D/DRC Case

823 Lady Street

DESIGN/DEVELOPMENT REVIEW COMMISSION
DESIGN REVIEW DISTRICT
EVALUATION SHEET
Informational Presentation

NATURE OF REQUEST: INFORMATIONAL PRESENTATION ONLY

A2.1

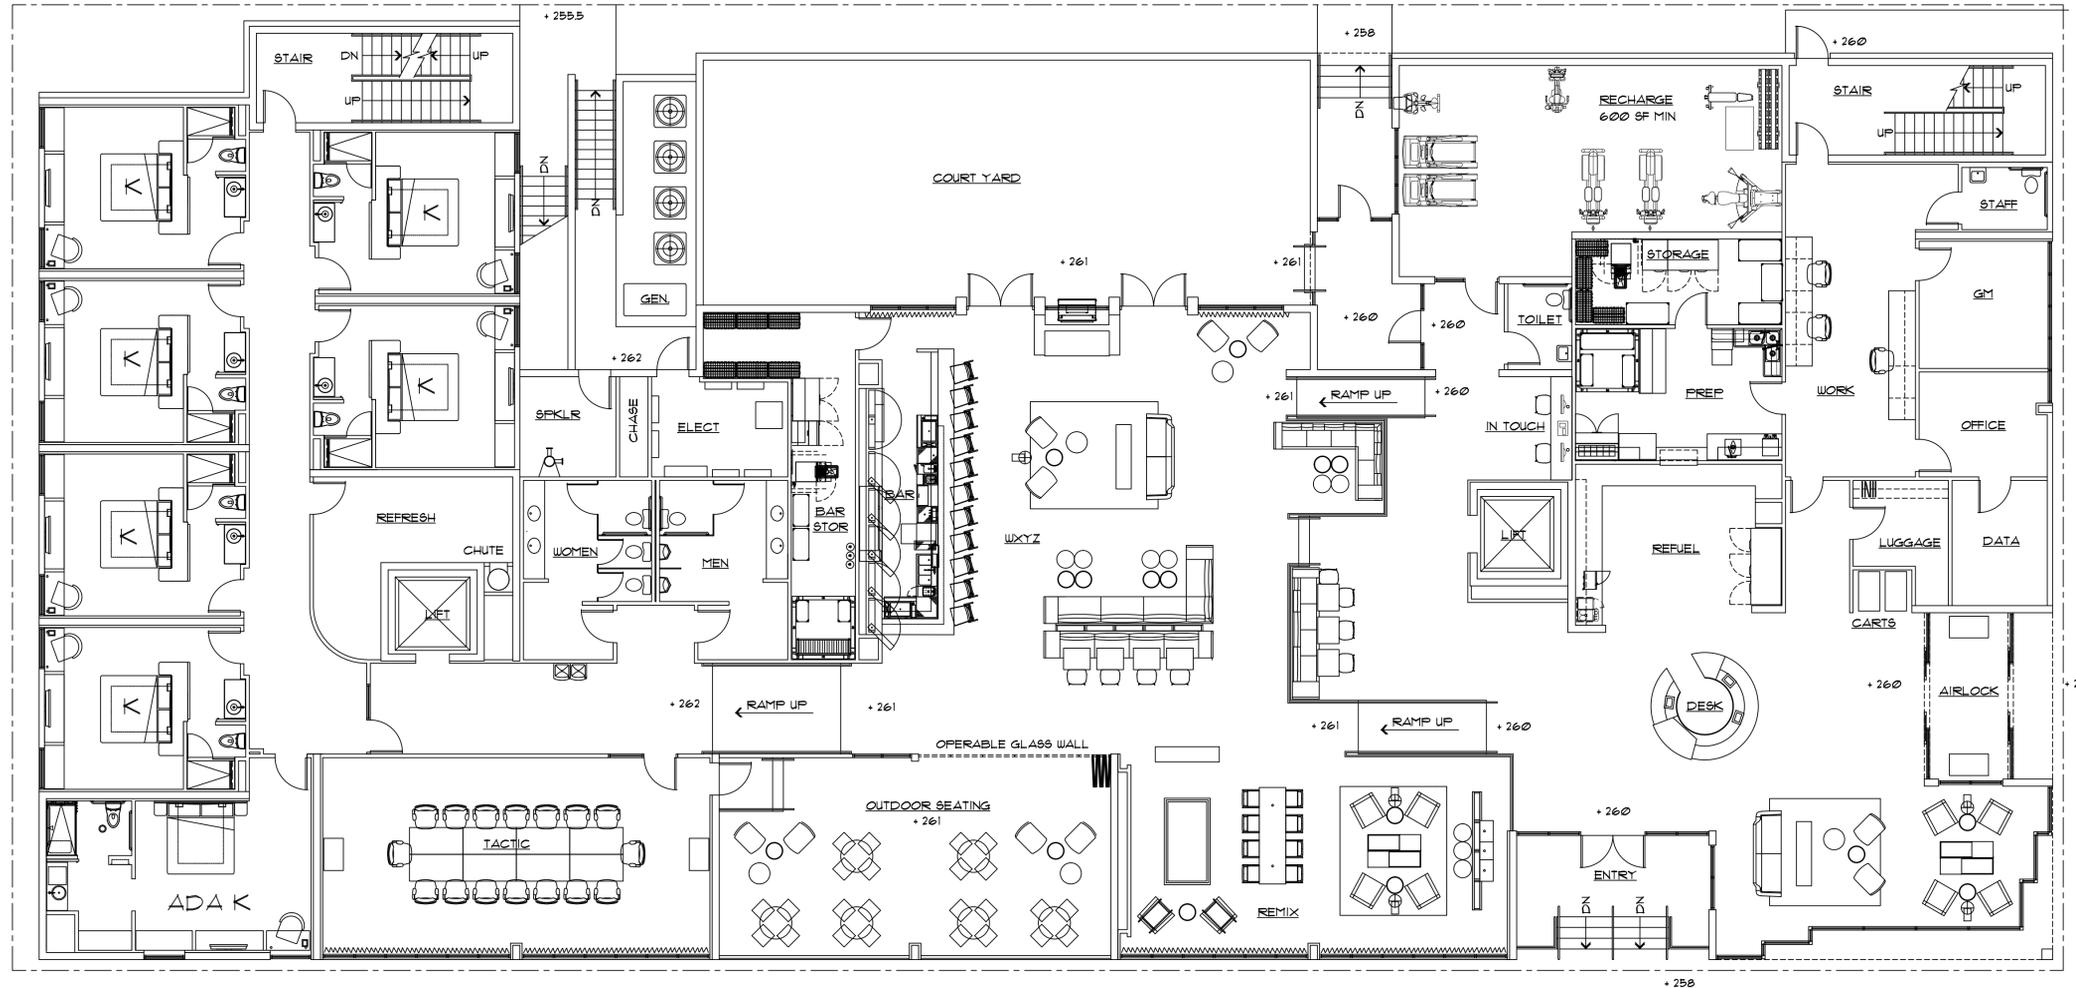
The percentage of storefront at the street level is very high at the corner and along the lobby. Along Lincoln Street, the blank brick wall at the corner will require some additional articulation such as a window into the stairwell.

Along Lady Street, the storefront is continuous until the grade starts to drop in front of the basement. While windows do not make sense here, this expanse of wall below the outdoor dining area needs something to maintain the interest of the pedestrian along this sidewalk. Windows were added along the western end of the Lady Street elevation at the restaurant at the request of staff, which helps with the overall percentage of window openings.

As mentioned previously, the black brick wall at the north end of the Lincoln Street elevation and the long stretch of basement wall along Lady Street needs to be articulated. Art on the wall could be an option, especially since the building is on the property line. Staff recommends that the developer contact One Columbia to discuss options for public art on this/these wall(s).

Lincoln would be considered the side street; there is close to 50% storefront, however adding a window to the blank portion of brick wall at the northern end of this elevation would be an improvement.

The Lady Street entrance is recessed more than the recommended 5 feet. However, it is a few feet above street level. As well, given the use of the building, hotels have an active presence 24/7 that would add a safety element to this space.

This building presents a materials challenge, due to the fact that it is more modern in design and using some less-traditional materials. The primary material is brick, which is considered appropriate and widely used. There are three additional materials that could be considered major elements on the building: aluminum panels on the corner tower, cement board panels on the Lincoln Street elevation, and stucco along the base on Lady Street. The aluminum panels are above the street level and make a statement on the corner of the building; they are also visually tied to the canopies and signage.

Staff recommends a single material be used at the base of the building, and the cement board panels nicely accentuate the horizontality of the building. This would help the design of both street elevations appear more unified. The cast concrete detailing is a recommended material and works well as an accent in the large expanse of brick, again emphasizing the strong horizontal lines of the design.
